November 20, 2023

ADDENDUM #1

Owen Valley Middle School Addition and Interior Renovations

SHEET NO:
E5
54 of 58

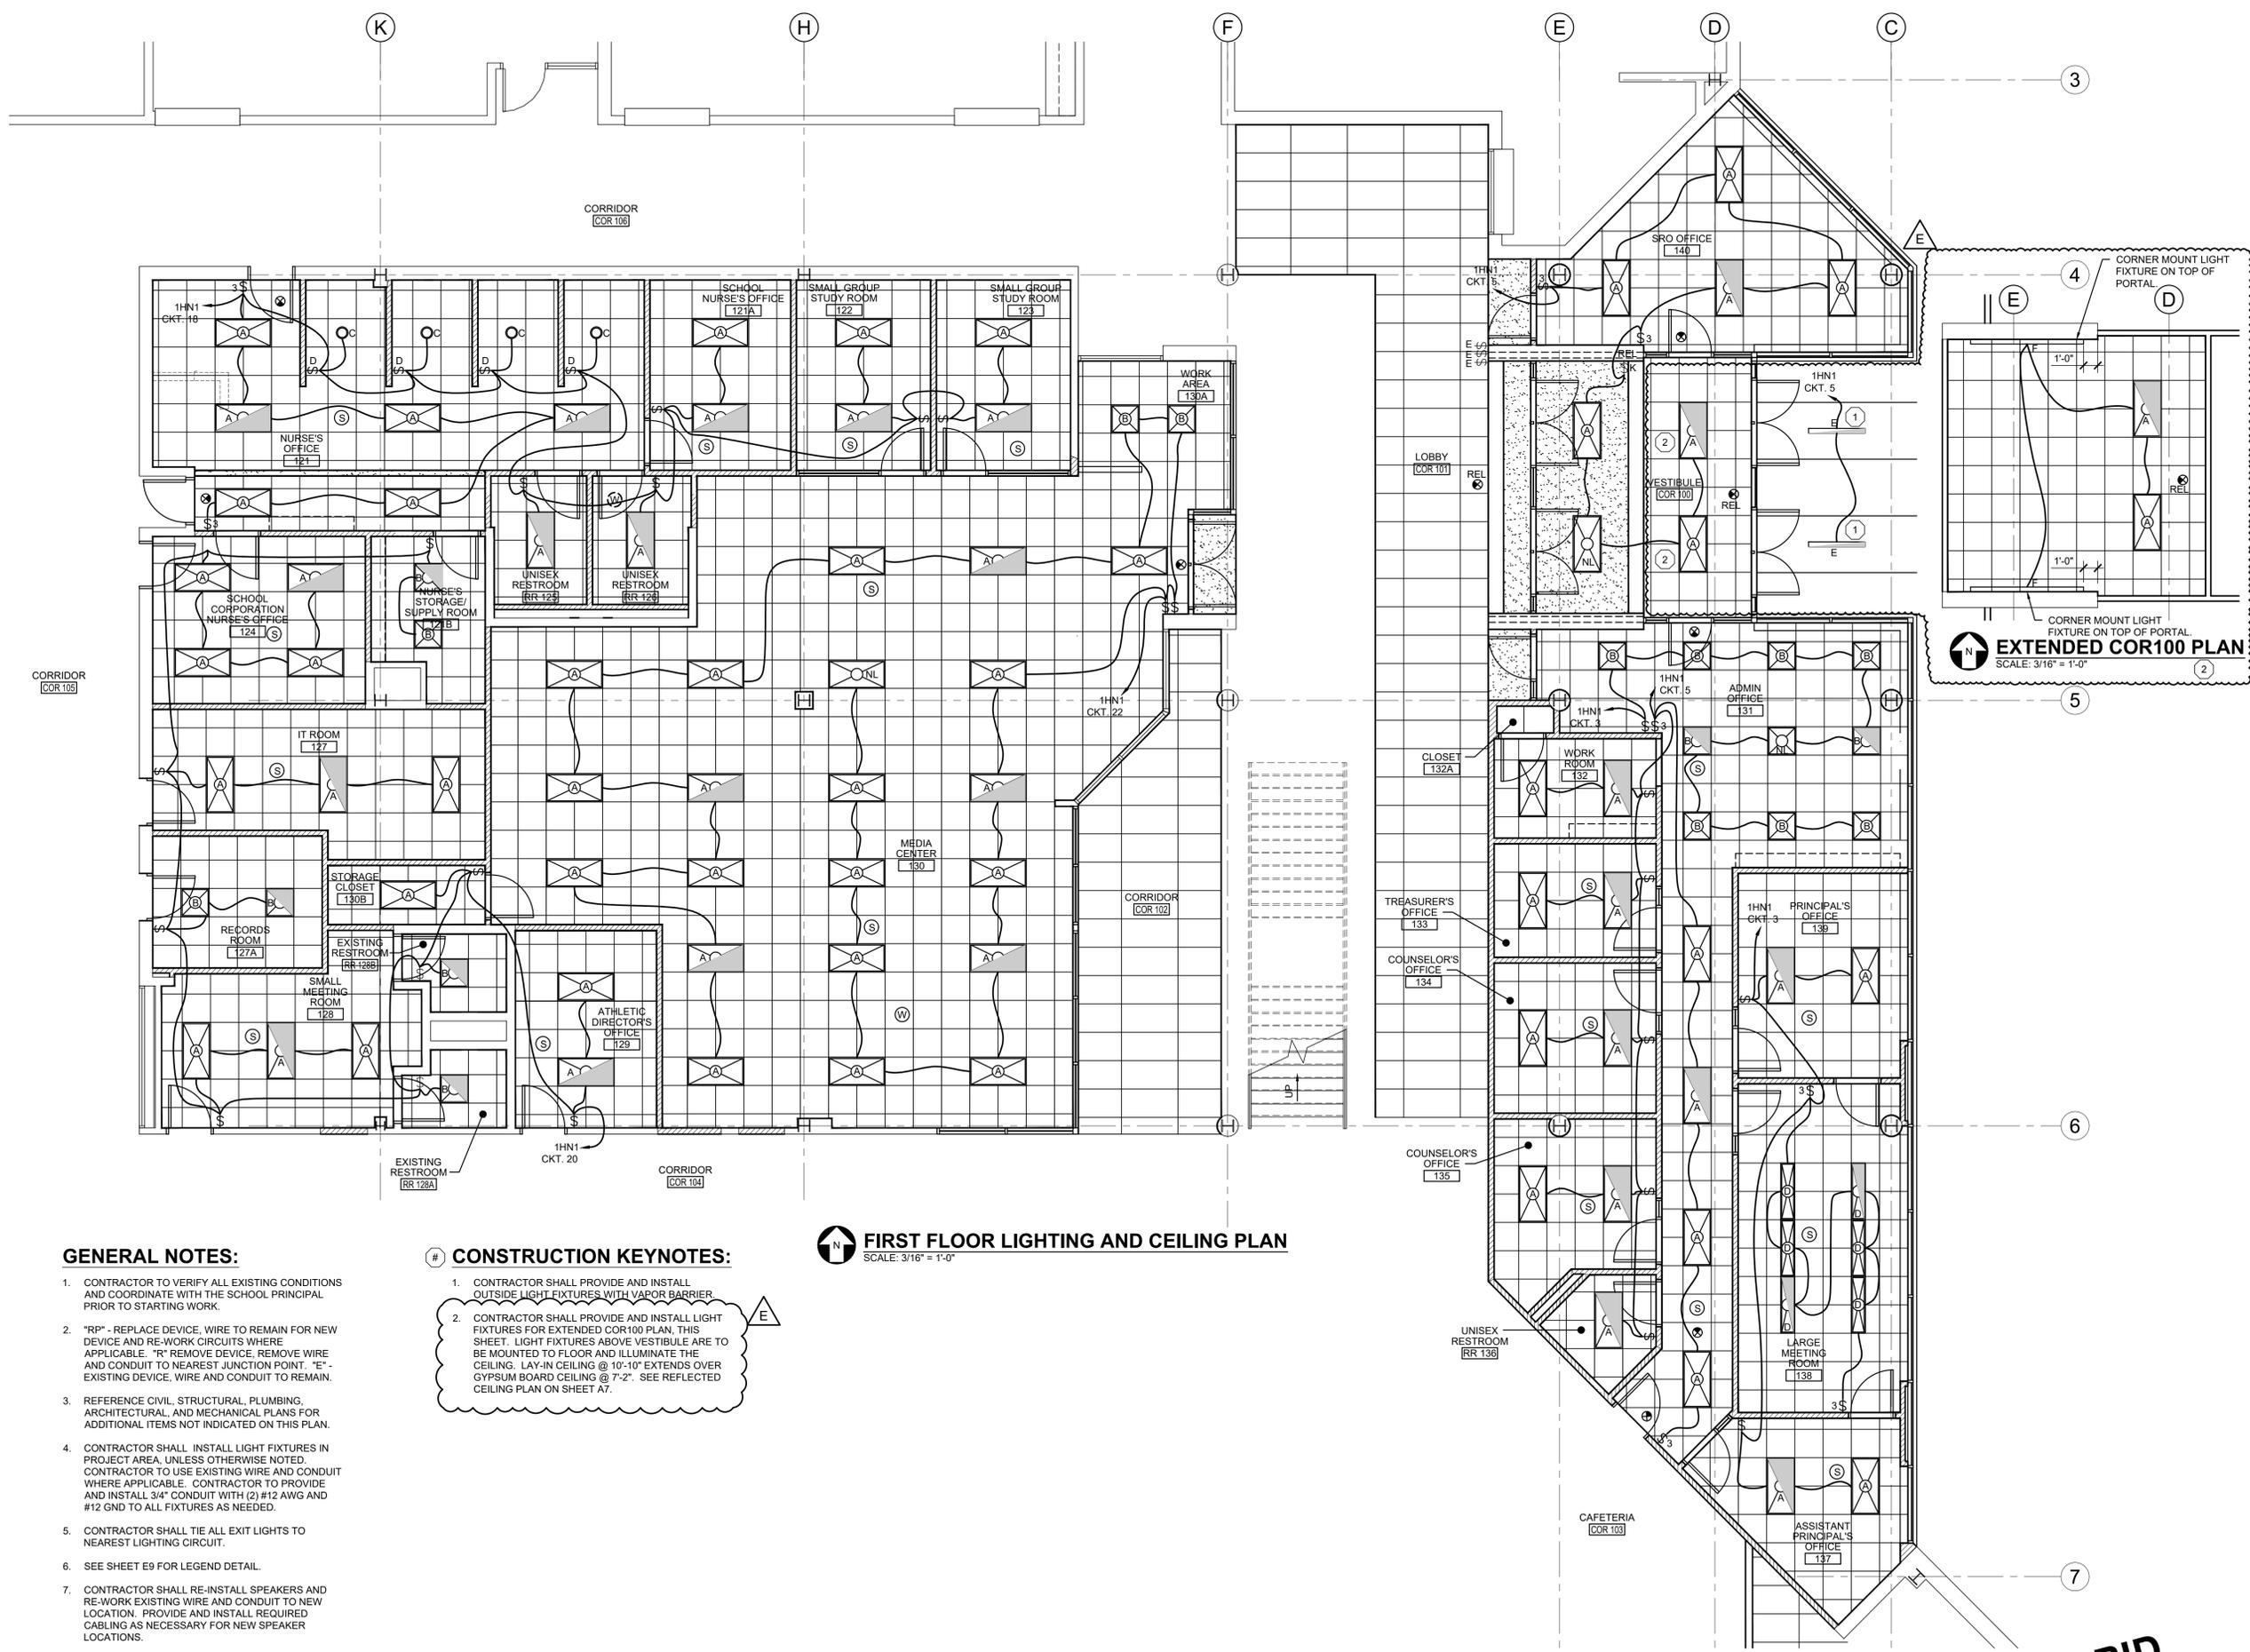
Sheet E5 - Light fixtures modified at the main entry and Extended Corridor Plan.
